Work Order ID 71818

Item Name: Crosstube Turning Detail

DART AEROSPACE LTD	Work Order: 71818
Description: Crosstube Assembly	Part Number: D407-667-245
Inspection Dwg: D407-667-245 Rev: F	Page 1 of 1

DRAWING NO. D407-667-245	TITLE CROSSTUBE ASSY (407 HIGH AFT)	REV. F	DART AEROSPACE LTD ENGINEERING ORDER		D.E.O. NO. D407-667-245-F-1	SHEET NO. SHEET 1 OF 2	SCALE NTS
DRAWN <i>JS</i>	CHECKED <i>97</i>	MFG. APPR. <i>BE</i>	APPROVED <i>140</i>	DE APPR. <i>H</i>			
DATE 11.04.08	DATE 11.04.12	DATE 11.04.12	DATE 11.04.12	DATE 11.04.12	DATE 11.04.12

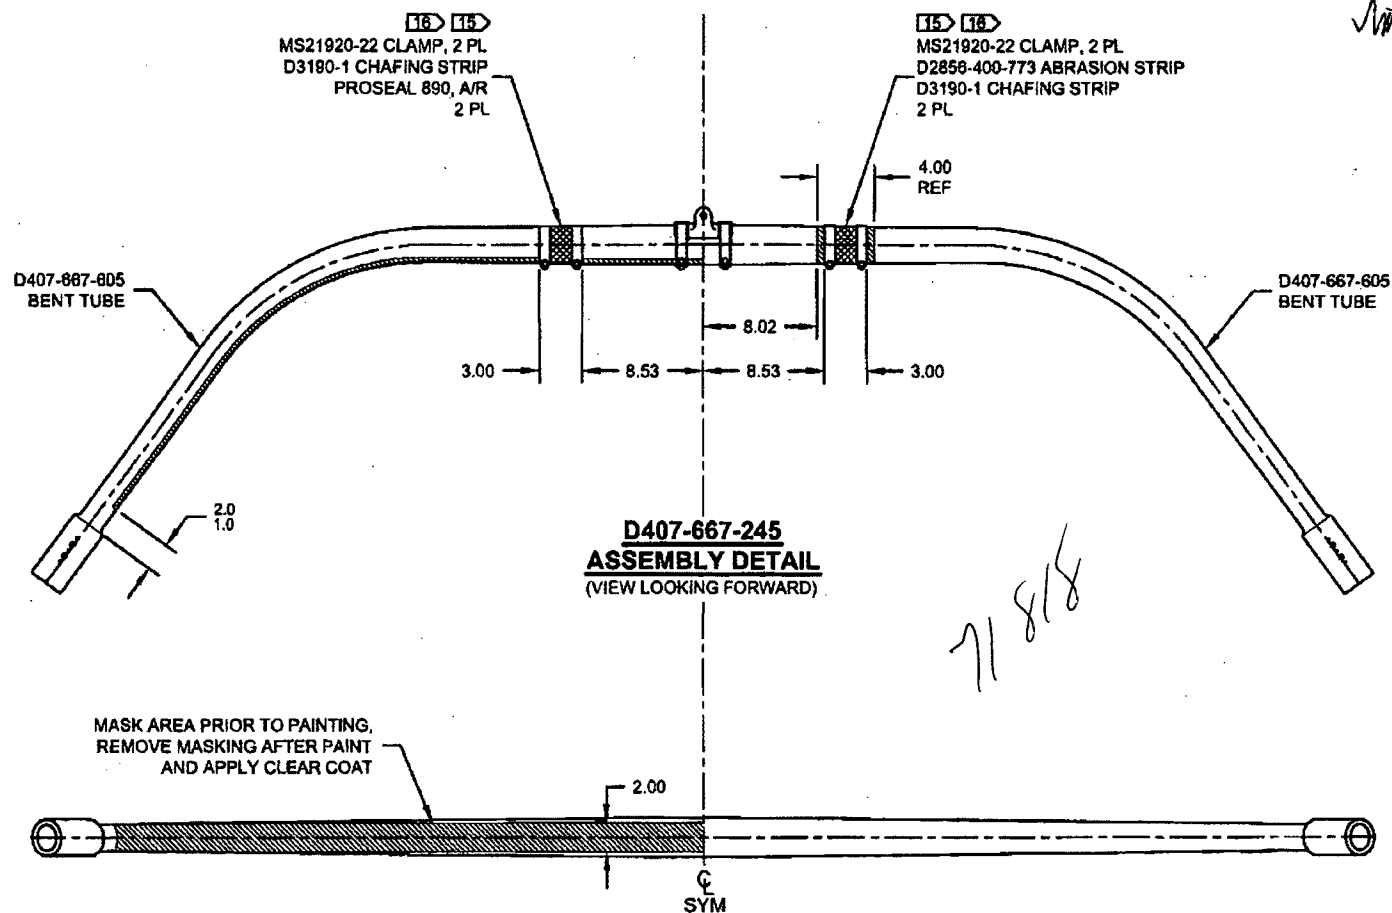
PURPOSE:

REMOVED ABRASION STRIP IN FAVOR OF A THIN LAYER OF PROSEAL 890.

- 2) FINISH: CHEMICAL CONVERSION COAT PER DART QSI 005 4.1
PRIME INSIDE AND OUTSIDE PER DART QSI 005 4.2
MASK UNDERSIDE OF CROSSTUBE AS SHOWN (HATCHED AREA) AND
PAINT OUTSIDE PER DART QSI 005 4.2
REMOVE MASKING AND APPLY CLEAR COAT
- 15) APPLY A THIN COAT OF PROSEAL 890 ON INSIDE CONCAVE SURFACE OF D3190-1
CHAFING SHIELDS AND LET CURE PER MANUFACTURER'S INSTRUCTIONS. INSTALL
PROSEALED D3190-1 CHAFING SHIELDS ONTO CROSSTUBE BY APPLYING A THIN COAT
OF PROSEAL 890 ONTO CROSSTUBE. BE SURE TO ELIMINATE ANY AIR GAPS.

- 2) FINISH: CHEMICAL CONVERSION COAT PER DART QSI 005 4.1
PRIME INSIDE AND OUTSIDE PER DART QSI 005 4.2
PAINT OUTSIDE PER DART QSI 005 4.2
- 15) INSTALL D2856-400-773 ABRASION STRIP WITH A 0.13 REF GAP ON BOTTOM SIDE OF
CROSSTUBE PER QSI 035.
